**ISO/IEC JTC 1/SC 17**  
**Cards and personal identification**  
**Secretariat: BSI (United Kingdom)**

**Document type:** Disposition of Comments Report

**Title:** Disposition of comments on: CD ISO/IEC 14443-4:2008/AM2 — Identification cards — Contactless integrated circuit(s) cards — Proximity cards — Part 4: Transmission protocol — AMENDMENT 2: Bits rates higher than fc/16 and up to fc

**Date of document:** 2011-05-26

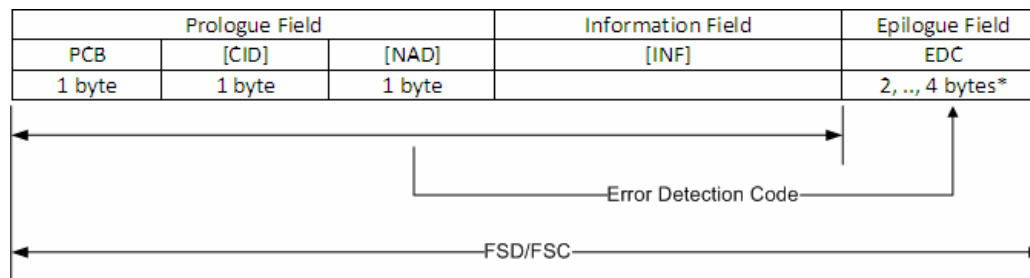
**Annex A.4**

\*2 Bytes for CRC\_A and CRC\_B, 4 Bytes for CRC\_32. Which EDC is used, depends on the selected frame format.”

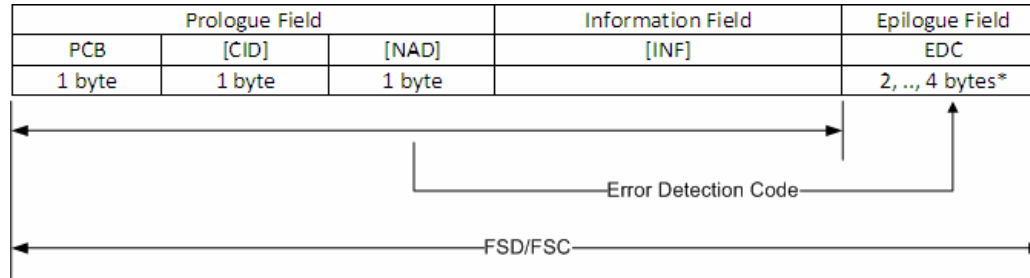
### Annex A.3

\*2 Bytes for CRC\_A and CRC\_B, 4 Bytes for CRC\_32. Which EDC is used, depends on the selected frame format.”
